# CITY OF ALBUQUERQUE

**Re: Townhouse**  
**623 14<sup>th</sup> St. NW**  
**Traffic Circulation Layout**  
Architect's Stamp 07-11-22 (K13-D083)

Based upon the information provided in your submittal received 07-15-22, the above referenced plan cannot be approved for Building Permit until the following comments are addressed:

1 Site Plan  
Scale: 1" = 10'-0"

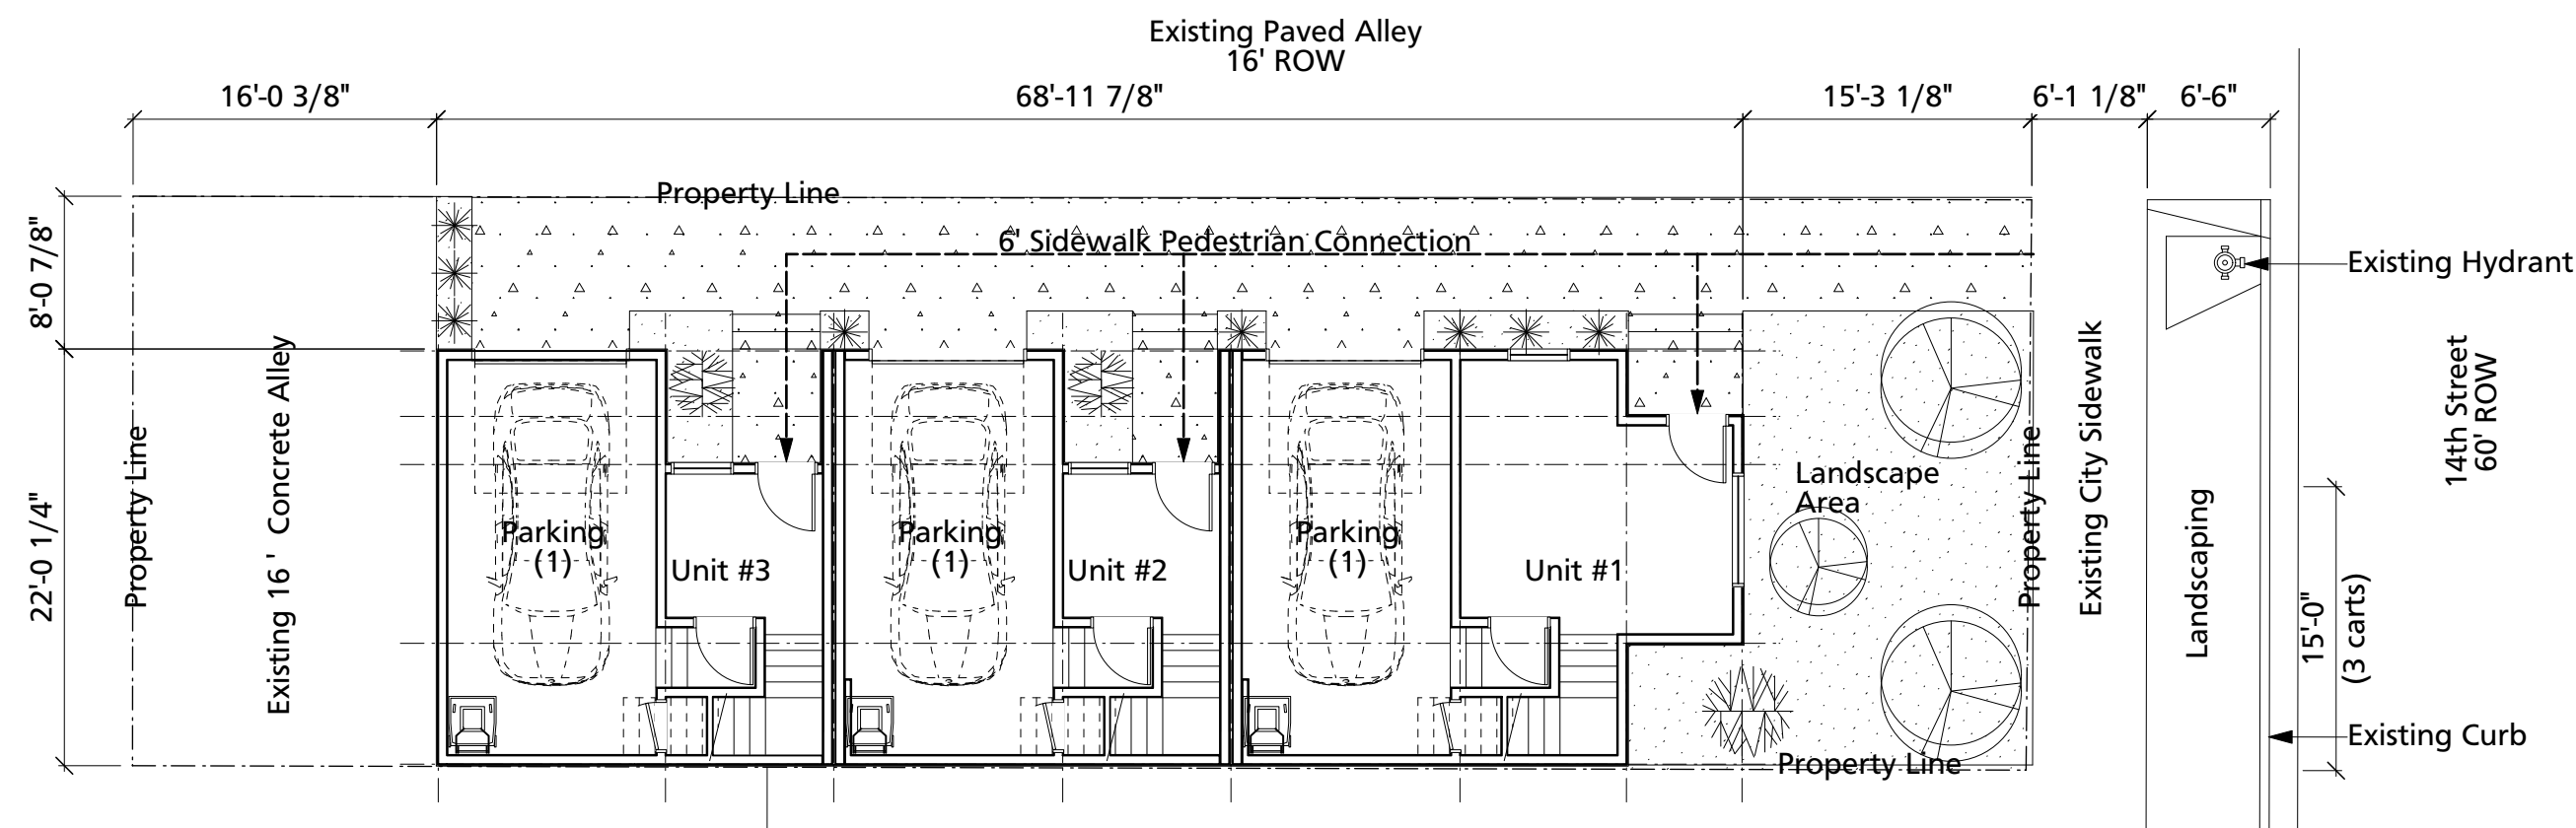
1. Provide the dimensions (width and length) for all the proposed parking spaces.
2. Provide shared access agreement with the property at the north side of your site.

3. Please define the pedestrian pathway from the public sidewalk to the building entrance, are there any ramps? If so, please provide all the proposed ramps details.

4. Please provide a sight distance exhibit
5. Show the clear sight triangle and add the following note to the plan: "Landscaping and signage will not interfere with clear sight requirements. Therefore, signs, walls, trees, and shrubbery between 3 and 8 feet tall (as measured from the gutter pan) will not be acceptable in the clear sight triangle. Please see attached Intersection sight triangle.

6. Please specify the City Standard Drawing Number when applicable.
7. Add a note stating "All broken or cracked sidewalk must be replaced with sidewalk and curb & gutter." A build note must be provided referring to the appropriate City Standard drawing.
